**Addendum No.1  
Request for Bids  
Greater Columbus Convention Center South Facility  
Air Handler Replacement**

Project: GCCC South Facility Air Handler Replacement

Heapy Project No. 2022-07014

Addendum 1 Description:

H101

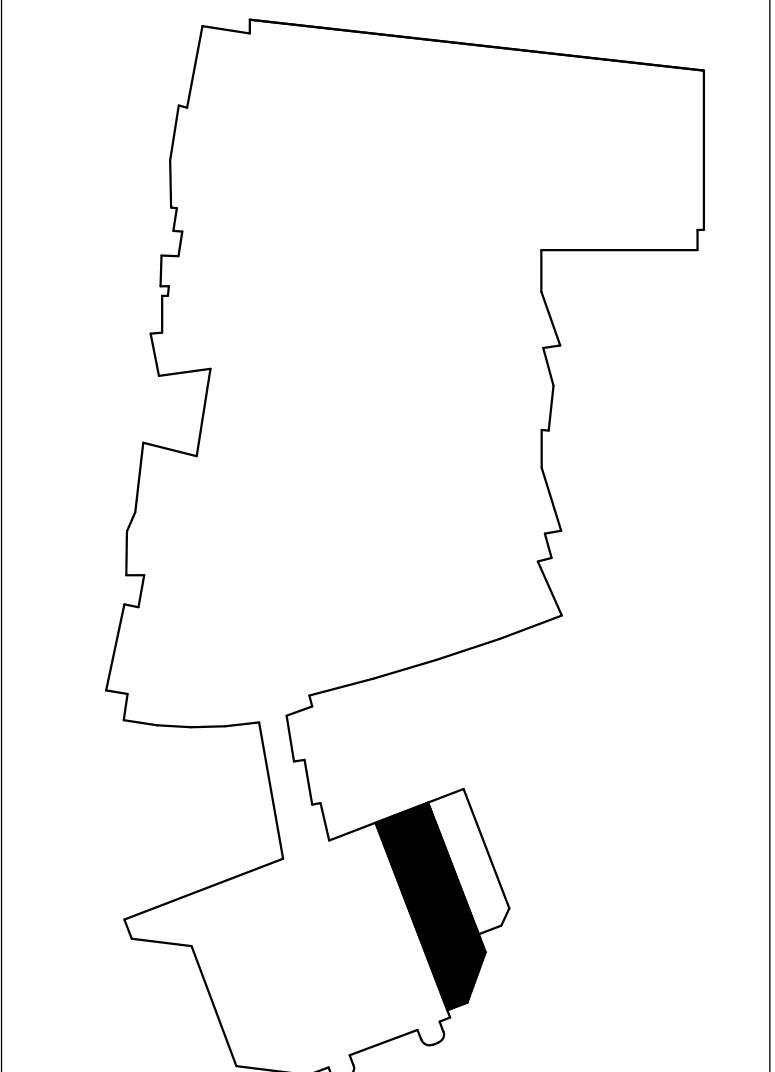
1. Sheet H001 – HVAC SCHEDULES
  - a. On Fan Schedule, changed Note 3 to read “PROVIDE AND INSTALL RETURN FAN AS PART OF ALTERNATE #3.”
2. Sheet H101 - SOUTH BUILDING LEVEL 4 MECH- ROOM - ENLARGED DEMO PLAN

- a. On vertical return duct on air handling unit AC-H-2, added coded note 27, which reads “ALTERNATE #5. DEMOLISH EXISTING VERTICAL SUPPLY DUCTWORK DROP TO FLOOR. EXISTING FIRE DAMPER AT FLOOR TO REMAIN. IF ALTERNATE IS NOT ACCEPTED, THEN EXISTING VERTICAL SUPPLY DUCTWORK DROP TO REMAIN.”

1. **Question** – Sheet H101, coded note 6 at column line OC-5/OC-M. Please confirm that the demolition of this vertical ductwork is part of Alternate 5. Same situation on sheet H102.  
**Answer** – Coded note 6 on H101 and H102 refers to demolition of the supply air vertical duct drop. Coded Note 6 on AC-H-2 and AC-H-4 will be revised to reference Alternate 5. Coded Note 6 on AC-H-1 and AC-H-3 is correctly referenced and is part of base bid.

27. ALTERNATE #5: DEMOLISH EXISTING VERTICAL SUPPLY DUCTWORK DROP TO FLOOR. EXISTING FIRE DAMPER AT FLOOR TO REMAIN. IF ALTERNATE IS NOT ACCEPTED, THEN EXISTING VERTICAL SUPPLY DUCTWORK DROP TO REMAIN.

SHEET TITLE  
SOUTH BUILDING LEVEL 4 MECH. ROOM - ENLARGED DEMO PLAN  
H102

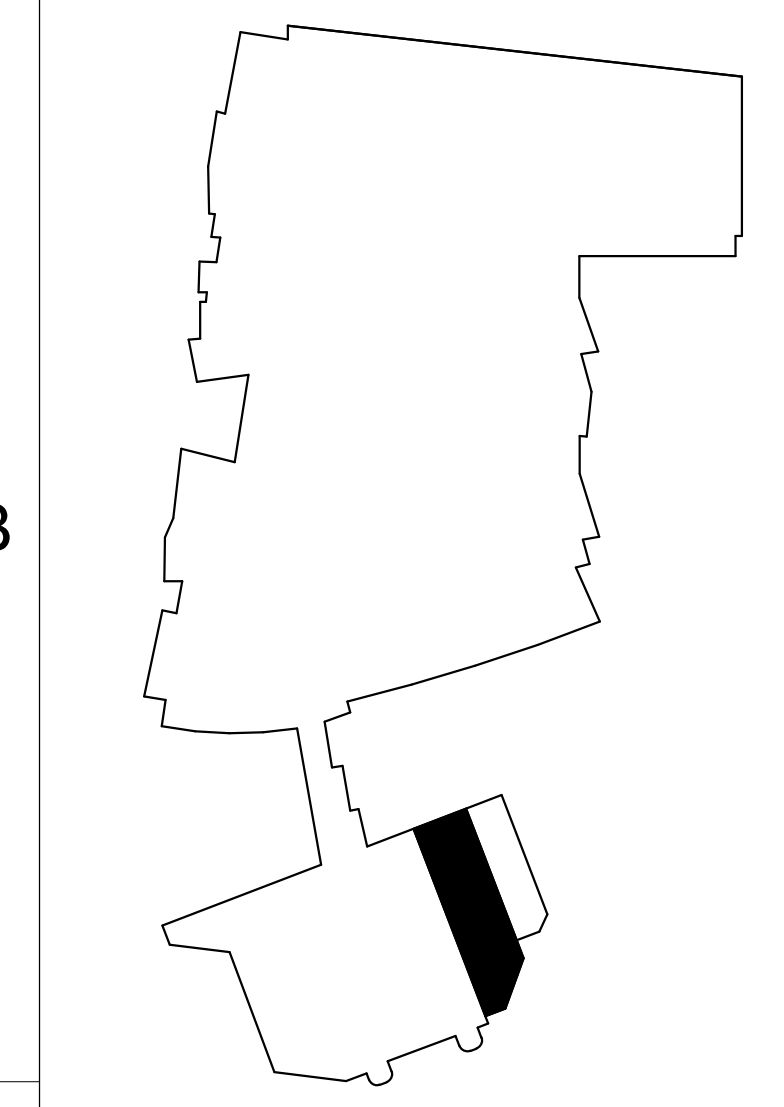
3. Sheet H102 - SOUTH BUILDING LEVEL 4 MECH- ROOM - ENLARGED DEMO PLAN
  - a. On vertical return duct on air handling unit AC-H-4, added coded note 28, which reads “ALTERNATE #5. DEMOLISH EXISTING VERTICAL SUPPLY DUCTWORK DROP TO FLOOR. EXISTING FIRE DAMPER AT FLOOR TO REMAIN. IF ALTERNATE IS NOT ACCEPTED, THEN EXISTING VERTICAL SUPPLY DUCTWORK DROP TO REMAIN.”

28. ALTERNATE #5: DEMOLISH EXISTING VERTICAL SUPPLY DUCTWORK DROP TO FLOOR. EXISTING FIRE DAMPER AT FLOOR TO REMAIN. IF ALTERNATE IS NOT ACCEPTED, THEN EXISTING VERTICAL SUPPLY DUCTWORK DROP TO REMAIN.

**SOUTH BUILDING LEVEL 4 MECH. ROOM - ENLARGED NEW WORK PLAN**  
H201

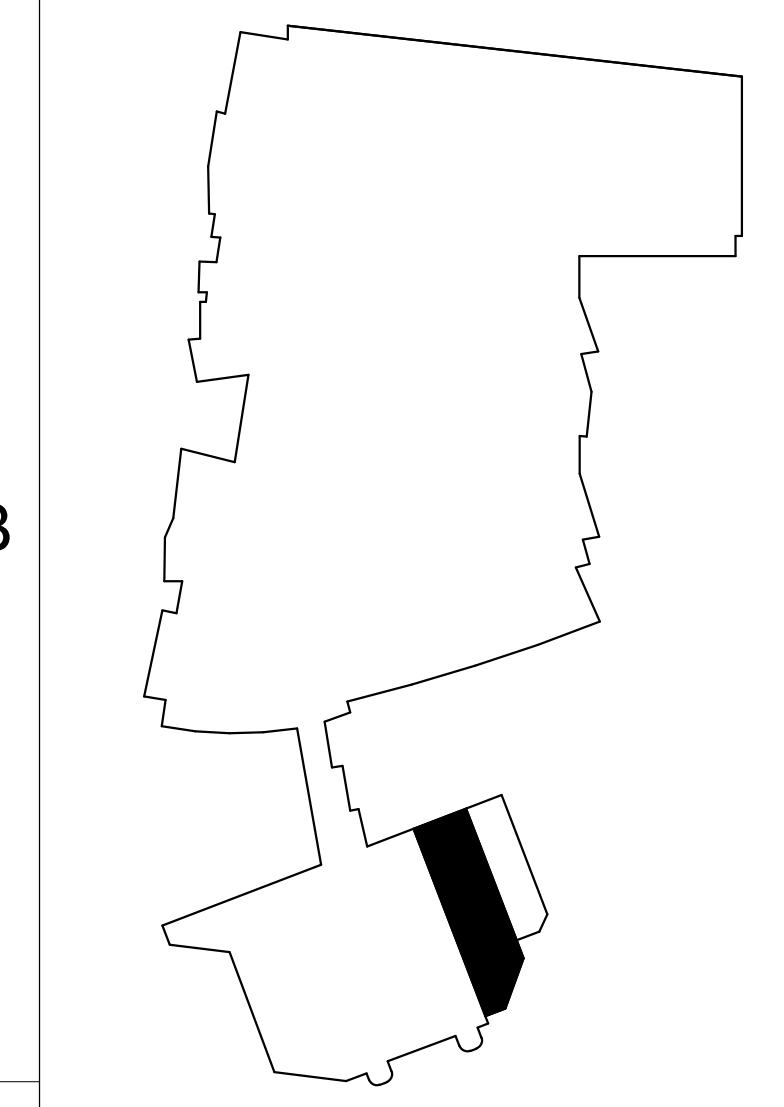
4. Sheet H201 - SOUTH BUILDING LEVEL 4 MECH- ROOM - ENLARGED NEW WORK PLAN
  - a. Changed Coded Note 13 to read “ALTERNATE #3. IF ALTERNATE #3 IS NOT ACCEPTED, EXISTING RETURN DUCT TO REMAIN.”

- b. On return air flow measuring station for air handling unit AC-H-2, added coded note 18, which reads “AIR FLOW MEASURING STATION IS PART OF ALTERNATE #5. IF ALTERNATE #3 IS NOT ACCEPTED, AIR FLOW MEASURING STATION TO BE INSTALLED IN EXISTING DUCT.”

- c. Added Coded Note 17 (reference to Alternate #5) on multiple items for air handling unit AC-H-2. See revised sheet for more information.
5. Sheet H202 - SOUTH BUILDING LEVEL 4 MECH- ROOM - ENLARGED NEW WORK PLAN

2. **Question** – Sheet H201, AC-H-2, coded note 13 is noted to be part of Alternate 5. It is between the return fan and ductwork that are noted to be part of Alternate 3. Please clarify. Same on sheet H202.  
**Answer** – Revise Coded note 13 on sheet H201 and H202 to read as follows:  
ALTERNATE #3. IF ALTERNATE #3 IS NOT ACCEPTED, EXISTING RETURN DUCT TO REMAIN.

3. **Question** – Sheet H201, notes 5 and 2 at AC-H-2. Should these be part of Alternate 5? Same on H202.  
**Answer** – Coded note 5 and 2 on H201 and H202 refers to supply air vertical duct drop. Another coded note will be added to AC-H-2 and AC-H-4 so that it is clear that AC-H-2 and AC-H-4 is to be part of Alternate 5. Coded Note 5 and 2 on AC-H-1 and AC-H-3 is correctly referenced and is part of base bid.

- 13. ALTERNATE #3. IF ALTERNATE #3 IS NOT ACCEPTED, EXISTING RETURN DUCT TO REMAIN.
- 14. ALTERNATE #3. IF ALTERNATE #3 IS NOT ACCEPTED, EXISTING RETURN AIR FAN TO REMAIN.

- 17. ALTERNATE #5. IF ALTERNATE #5 IS NOT ACCEPTED, EXISTING AIR HANDLING UNIT, PARTIAL CONCRETE BASE AND ACCESSORIES TO REMAIN.
- 18. AIR FLOW MEASURING STATION IS PART OF ALTERNATE #5. IF ALTERNATE #5 IS NOT ACCEPTED, AIR FLOW MEASURING STATION TO BE INSTALLED IN EXISTING DUCT.

SHEET TITLE  
SOUTH BUILDING LEVEL 4 MECH. ROOM - ENLARGED NEW WORK PLAN  
H202

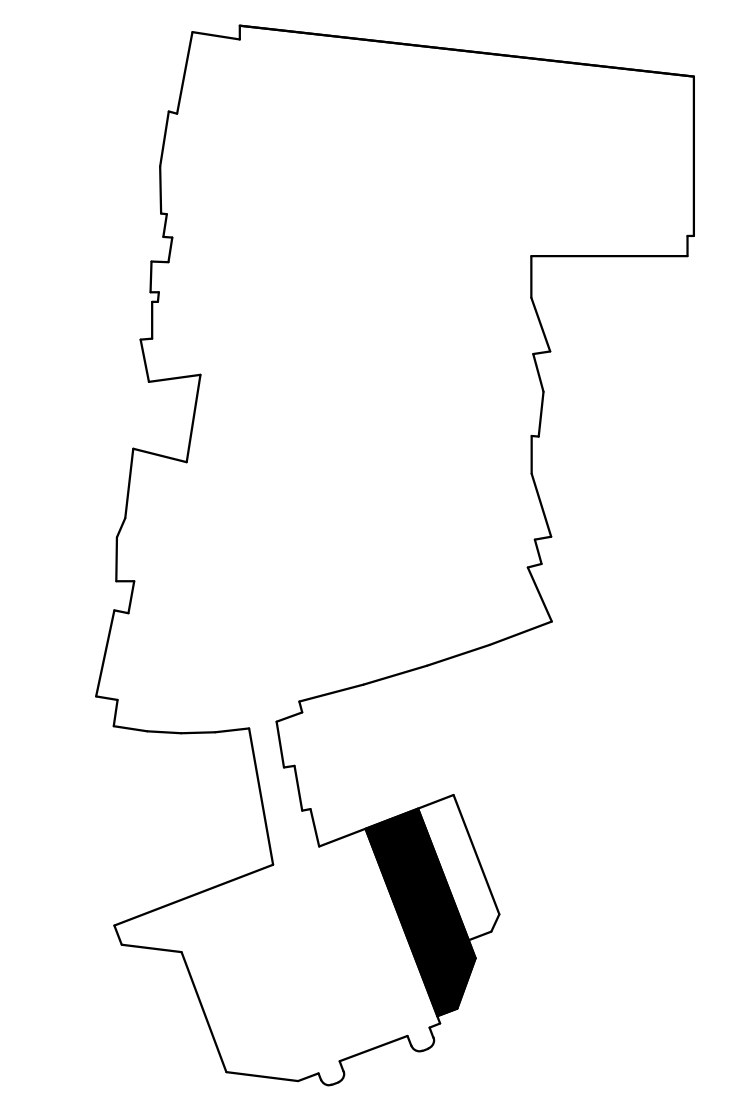
- a. Changed Coded Note 13 to read “ALTERNATE #3. IF ALTERNATE #3 IS NOT ACCEPTED, EXISTING RETURN DUCT TO REMAIN.”
  - b. On return air flow measuring station for air handling unit AC-H-4, added coded note 18, which reads “AIR FLOW MEASURING STATION IS PART OF ALTERNATE #5. IF ALTERNATE #3 IS NOT ACCEPTED, AIR FLOW MEASURING STATION TO BE INSTALLED IN EXISTING DUCT.”

- c. Added Coded Note 17 (reference to Alternate #5) on multiple items for air handling unit AC-H-4. See revised sheet for more information.

13. ALTERNATE #3. IF ALTERNATE #3 IS NOT ACCEPTED, EXISTING RETURN DUCT TO REMAIN.
14. ALTERNATE #4. IF ALTERNATE #4 IS NOT ACCEPTED, EXISTING RETURN DUCT TO REMAIN.

17. ALTERNATE #6. IF ALTERNATE #6 IS NOT ACCEPTED, EXISTING AIR HANDLING UNIT TO REMAIN.
18. AIR FLOW MEASURING STATION IS PART OF ALTERNATE #6. IF ALTERNATE #6 IS NOT ACCEPTED, AIR FLOW MEASURING STATION TO BE INSTALLED IN EXISTING DUCT.
